Village of Downers Grove

Report for the Village Council Meeting

Subject	1205 - 1219 Ogden Avenue – Vacation of Public Alley, Final Plat of Subdivision, Planned Unit Development, Zoning Map Amendment and a Special Use
Submitted By	Stan Popovich, AICP, Director of Community Development

1.) View from Garage, No sound barrier will be present, direct residential exposure of cars, customers, noise and lights.

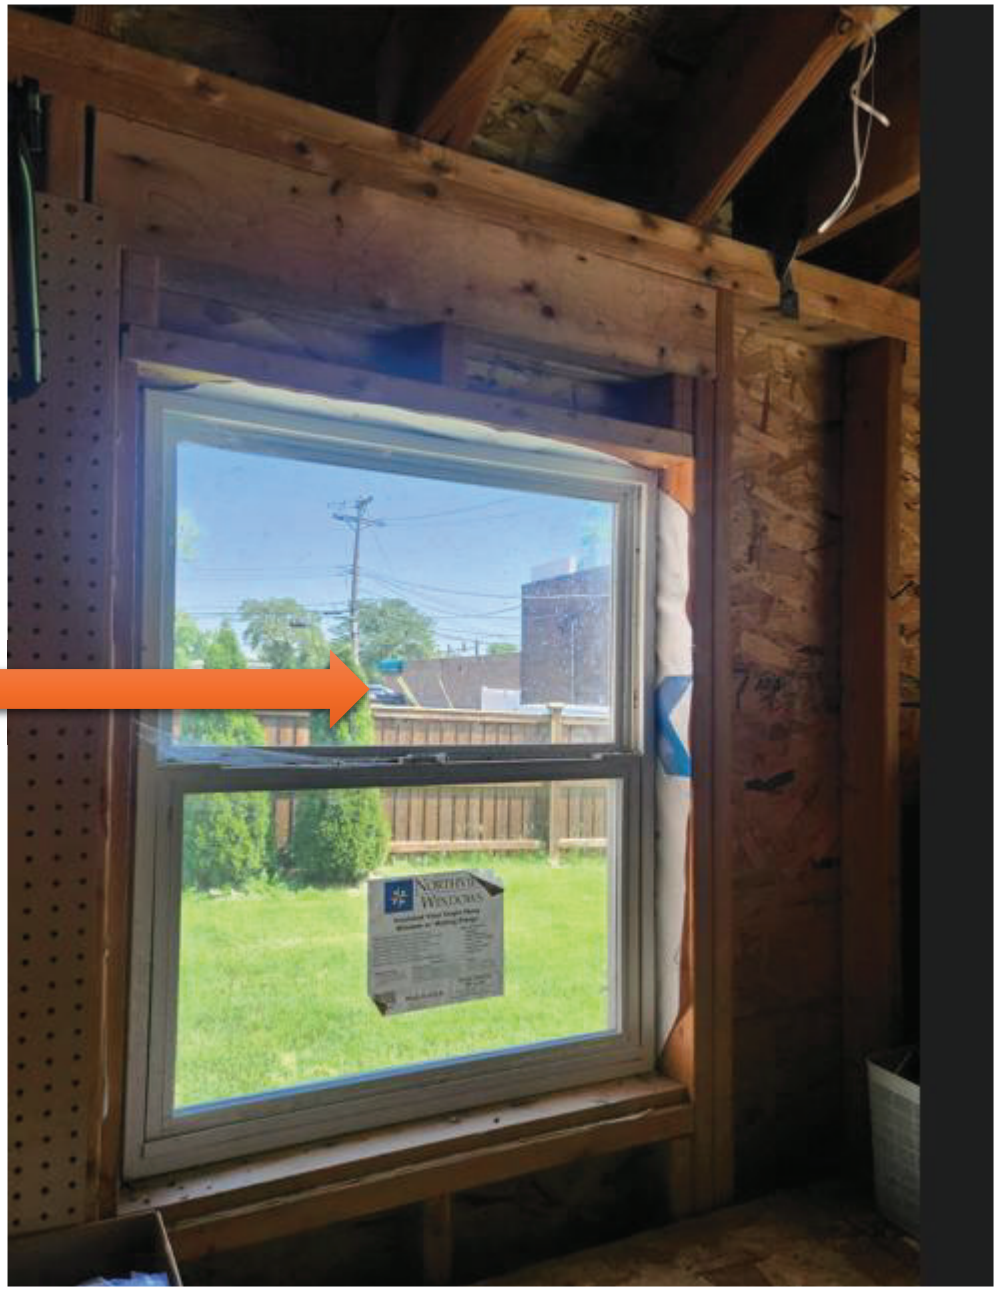
Where the Dutch brothers building will be located as well as menu, employees, customers, and walk up window.

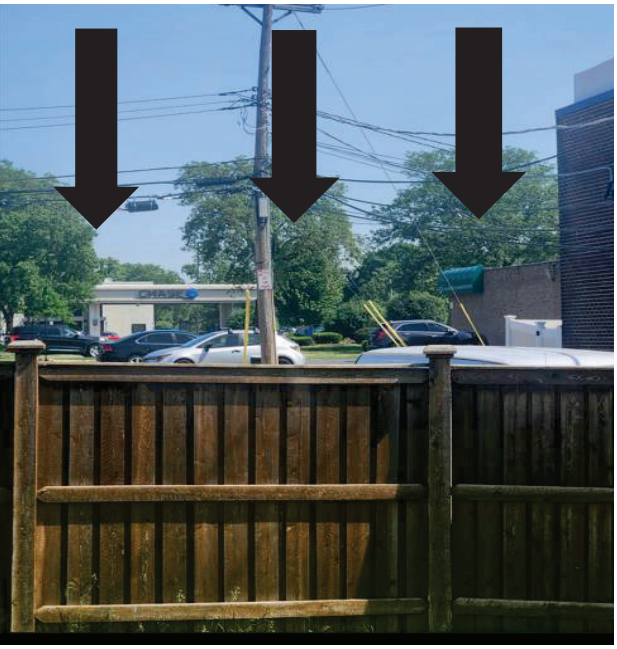
2.) View from behind our garage, where we have an active play area for our children with a swing set, No sound barrier will be present, direct residential exposure of lights, cars, customers, and constant noise (4:30am-11:30pm/12am). Cars will face directly into our yard due to the right turn from Ogden to sit and wait to enter the drive-thru line. (Constant flow of cars facing into our yard and home AM to PM).

Where cars will turn in off of Ogden to wait to turn left into the drive thru lane and cars waiting in drive thru lanes.

Will see stacked cars waiting in drive-thru lane as well as cars waiting to turn right from the alley into the establishment off of Saratoga.

3.) View from one angle of our backyard patio. No sound barrier will be present, direct residential exposure of lights, cars, customers, and constant noise (4:30am-11:30pm/12am).

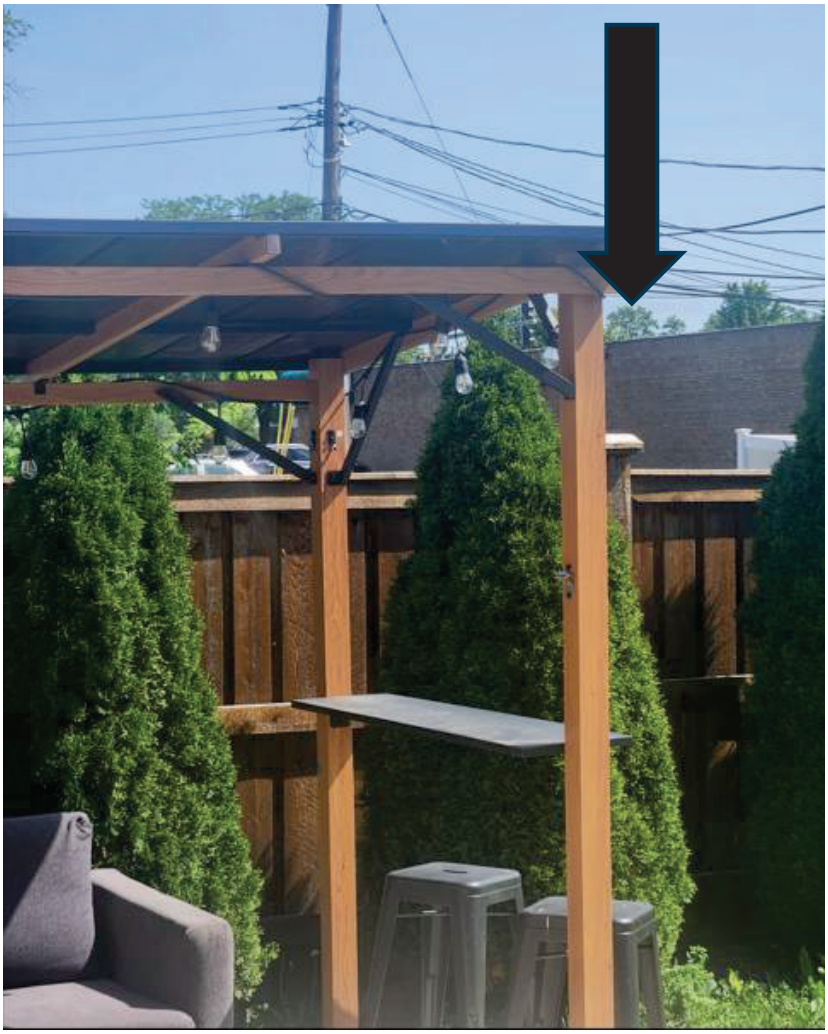
Where building, walk-up window, as well as drive-thru waiting lines will be in view.

4.) View from children's playroom. No sound barrier will be present, direct residential exposure of lights, cars, customers, and constant noise (4:30am-11:30pm/12am).

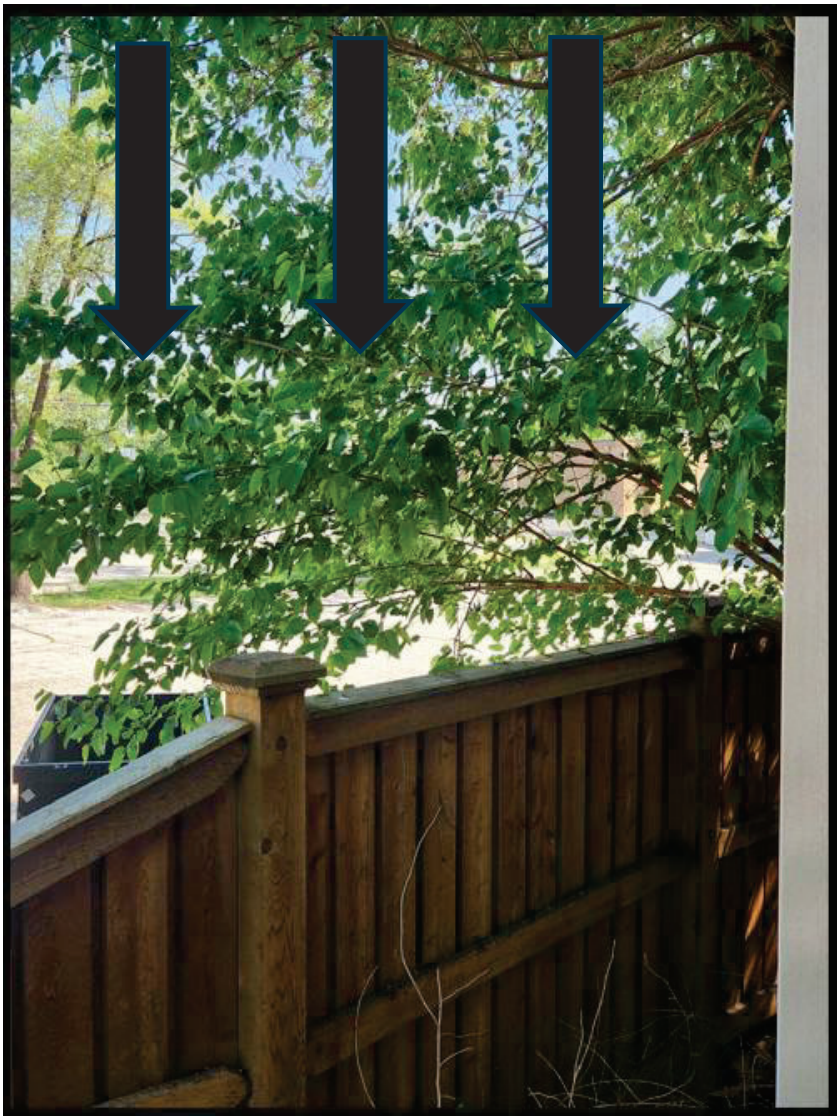
Once the leaves fall off the trees, the view will be extreme of all issues.
